Geotechnical Exploration, Inc.

Job No. 16-11251

Subject: **Response to City of San Diego Cycle Review Comments LDR-Geology: Project No. 508125, Cycle Issue 11**
Proposed Foxhill Residence
7007 Country Club Drive
La Jolla, California

Slope Stability Analysis

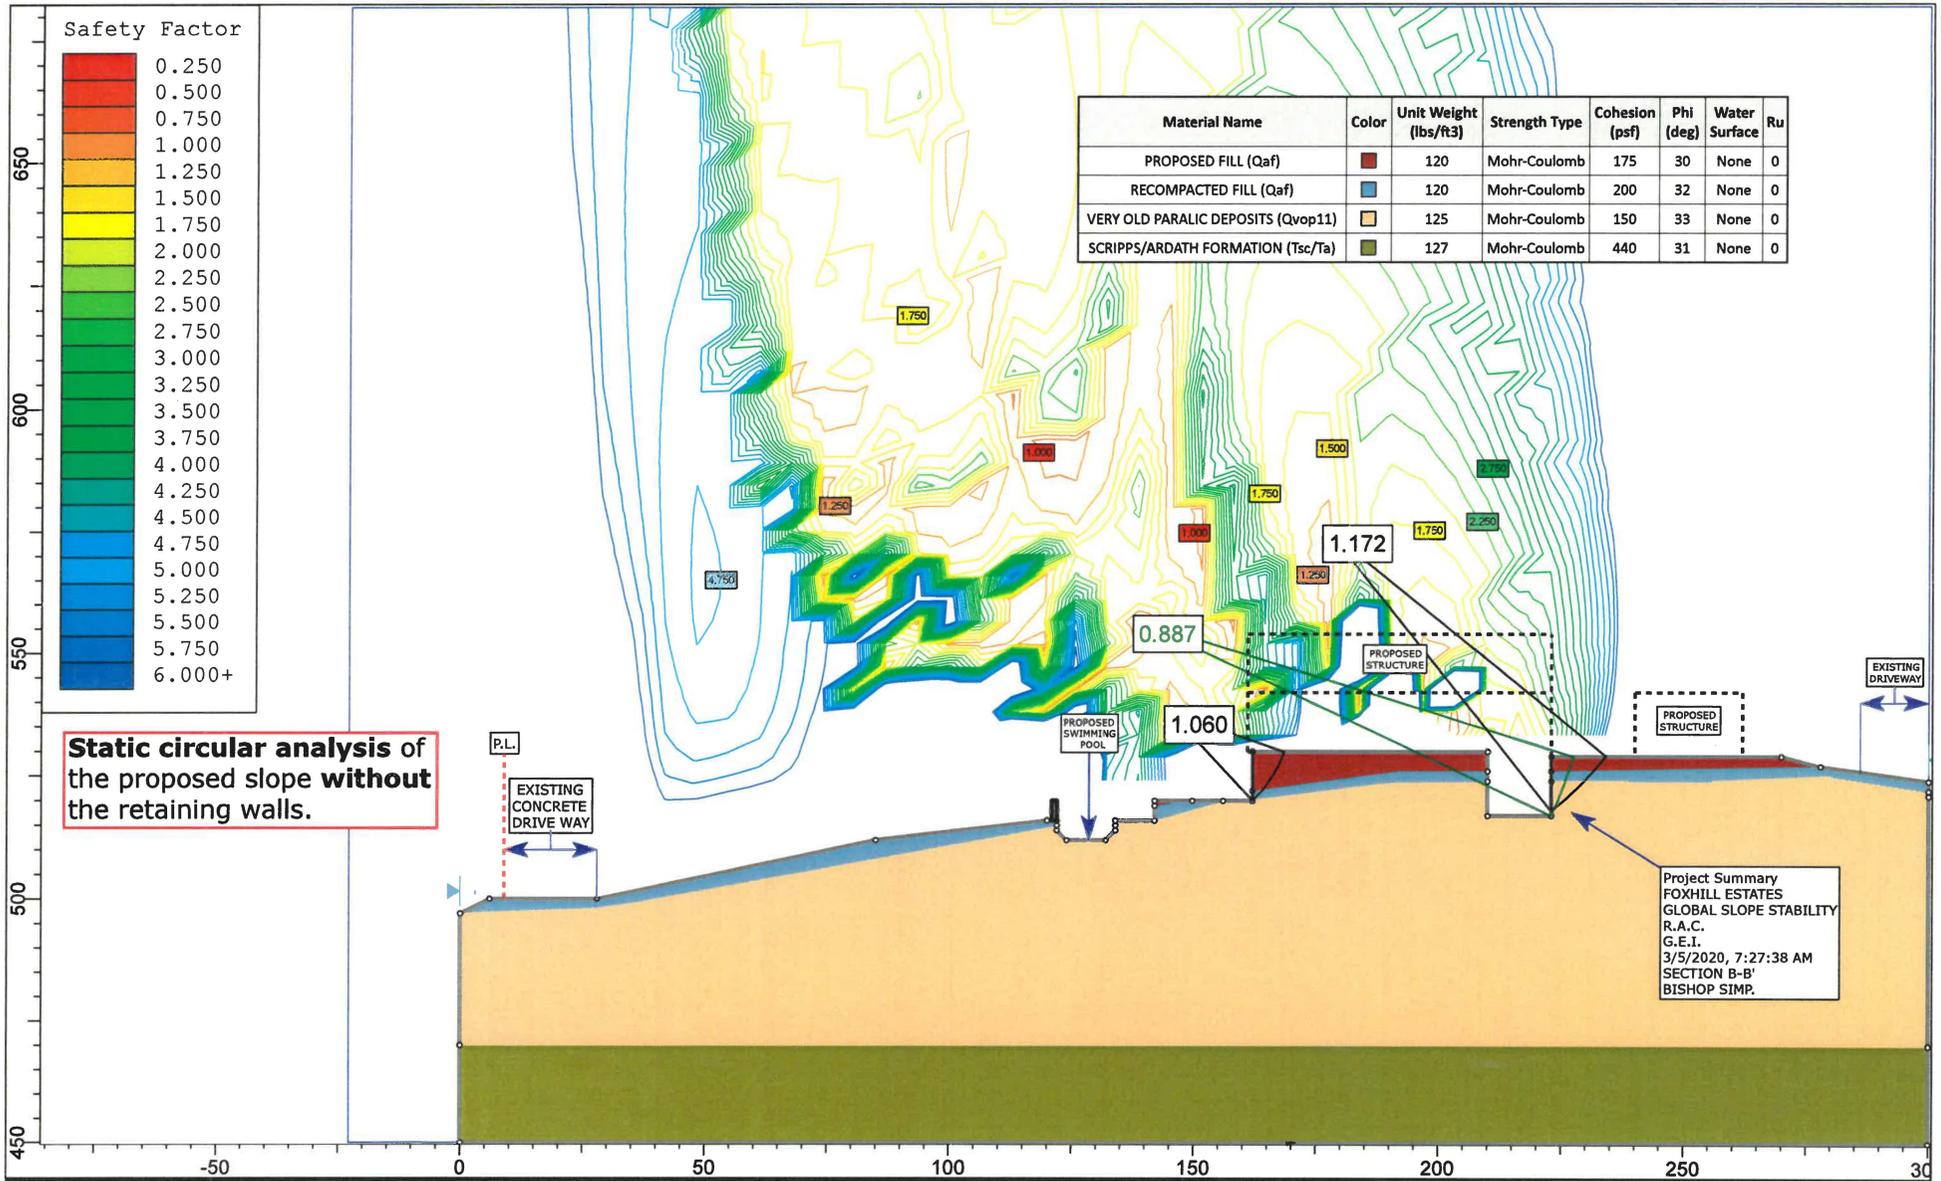
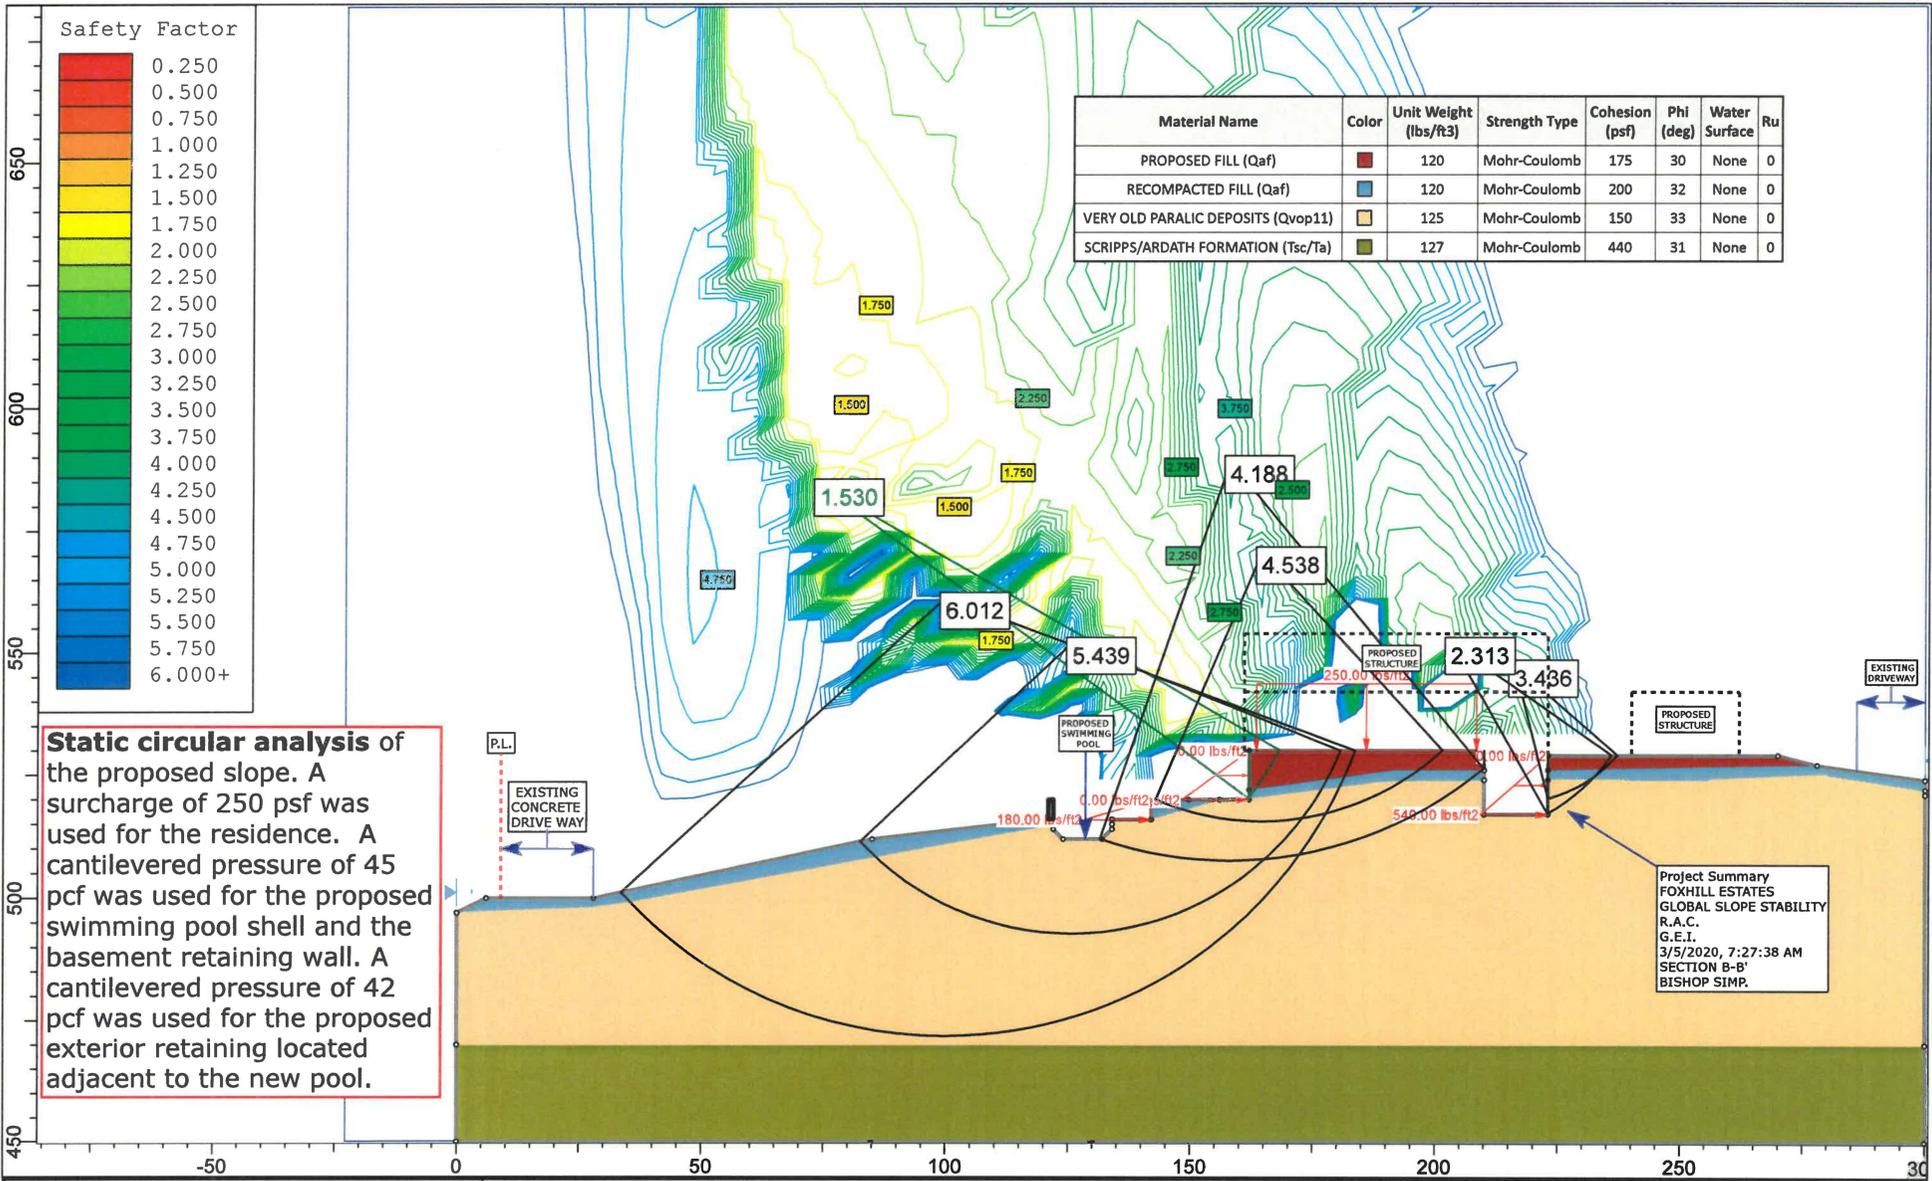
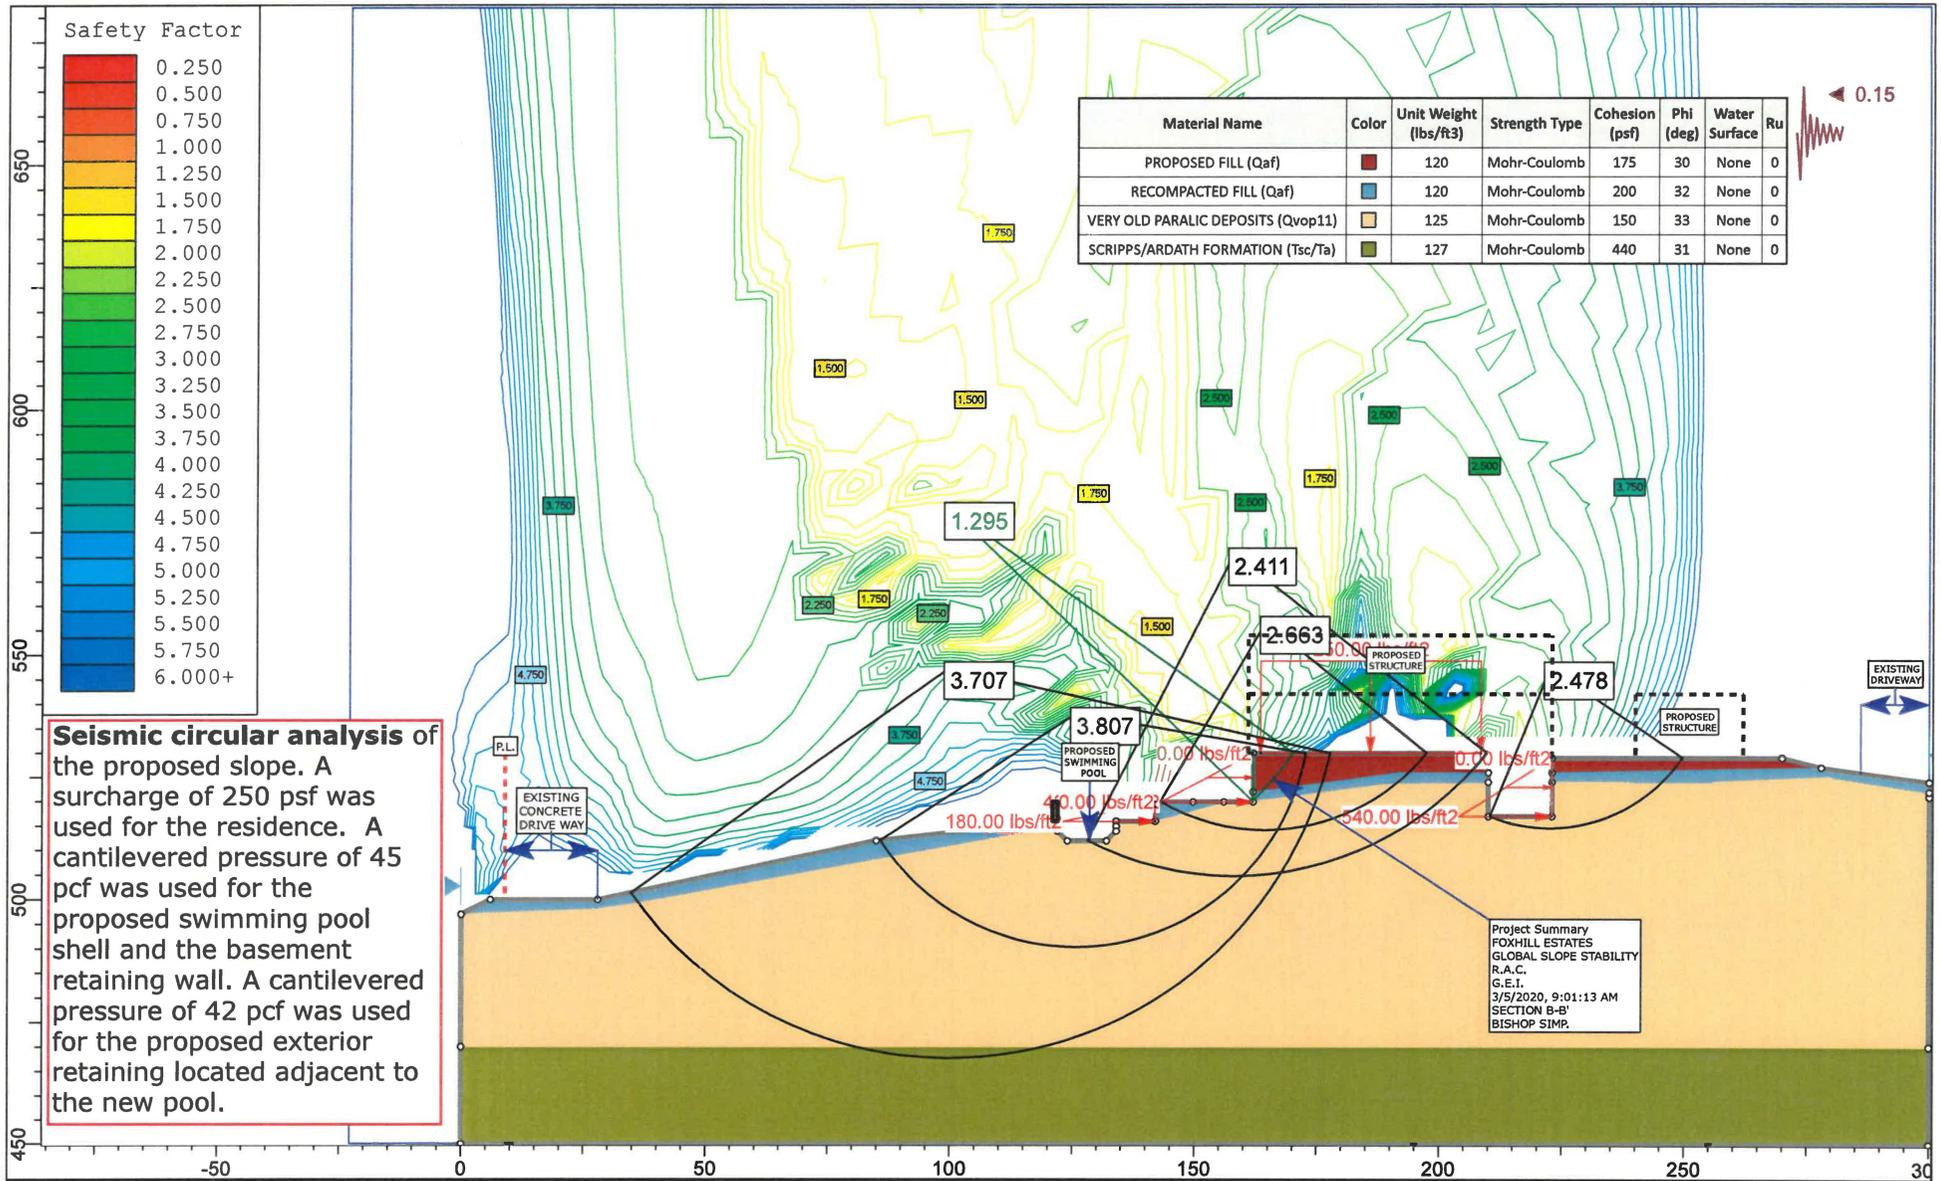
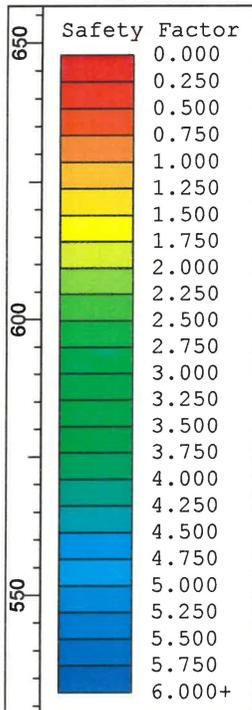
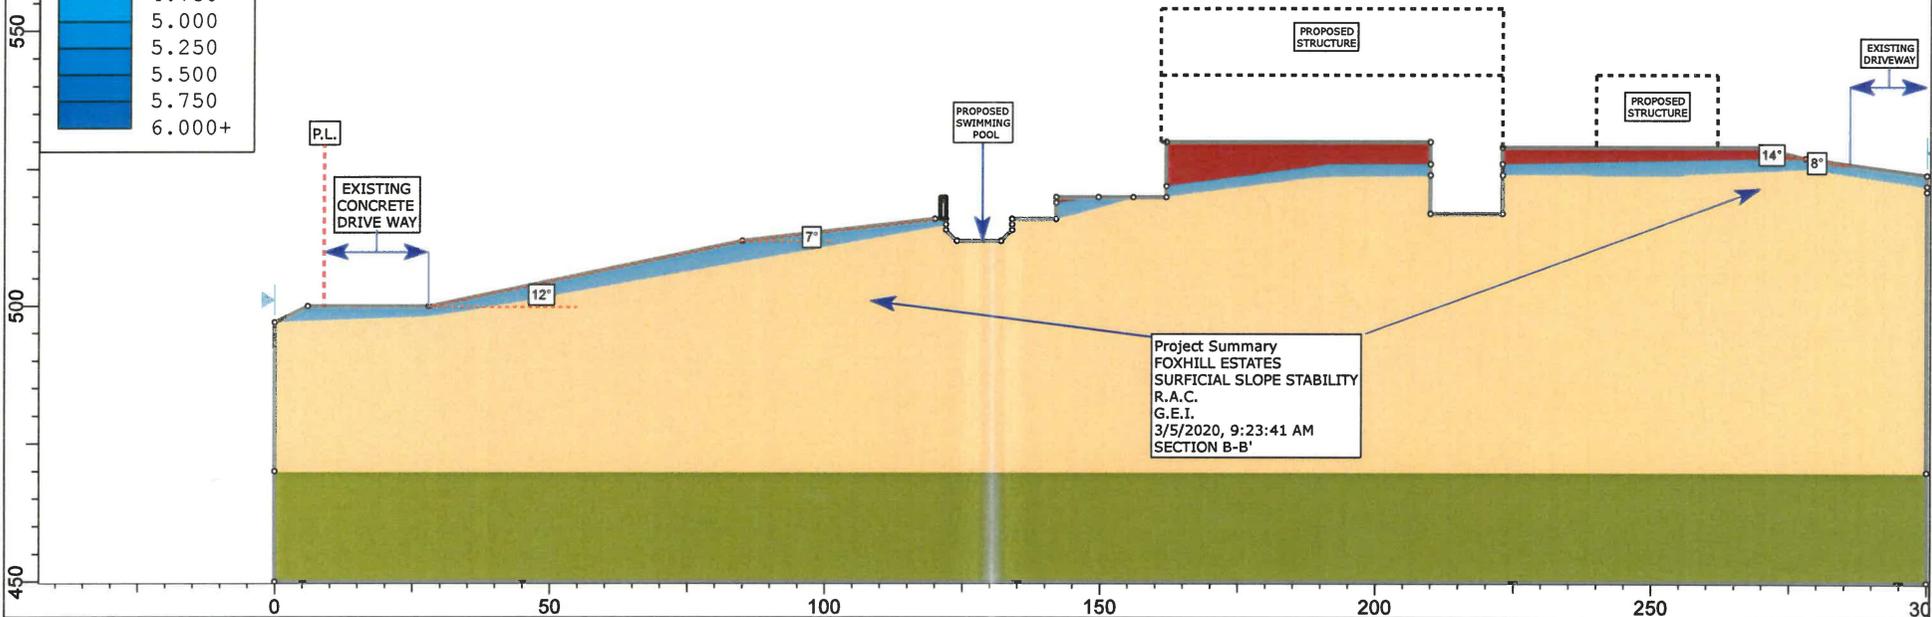
Issue No. 7: The project's geotechnical consultant must provide a professional opinion that the site will have a factor-of-safety of 1.5 or greater, for both gross and surficial, following project completion. (Outstanding Issue from Cycle 2)

GEI Response: Attached to this addendum update letter are the slope stability calculations addressing the global and surficial stability after the completion of the proposed development. We performed global and surficial stability along geologic cross-section B-B'. Refer to Appendix C for slope stability calculations. The global stability yielded a factor of safety of 1.5 or greater for static conditions, and a factor of safety of 1.5 or greater under seismic conditions. Surficial failure analysis yielded a factor of safety greater than 1.5. Please, refer to Figure Nos. Ia-b for the geologic cross-section locations on the Plot Plans with Site-Specific Geology. Refer to Figure Nos. IIa-c for Geologic Cross-Sections.

The static gross stability factors of safety were calculated and yielded a factor of safety value above 1.5 and greater with the inclusion of the basement retaining wall.

Once the static gross stability was determined for each section, a seismic analysis was performed for the same analyzed sections. The seismic analysis yielded a factor of safety value above 1.15 as required by the City of San Diego and the State of California.

The Factor of Safety values are **ABOVE** 1.50 and are adequate.
